# 11. COA-052000-2019

1114 North 25<sup>th</sup> Street

# Commission of Architectural Review

## STAFF REPORT

Figure 6. Detail of adjacent fence.

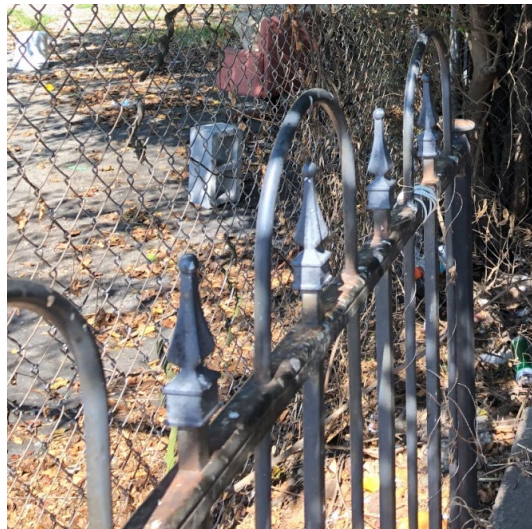
The applicant has confirmed that the proposed fence will match the style, height, and materials of the historic fence on the adjacent property and staff recommends approval of the proposed fence with the condition that the final specifications be submitted to staff for review and approval.

- The final fence specifications be submitted to staff for review and approval.
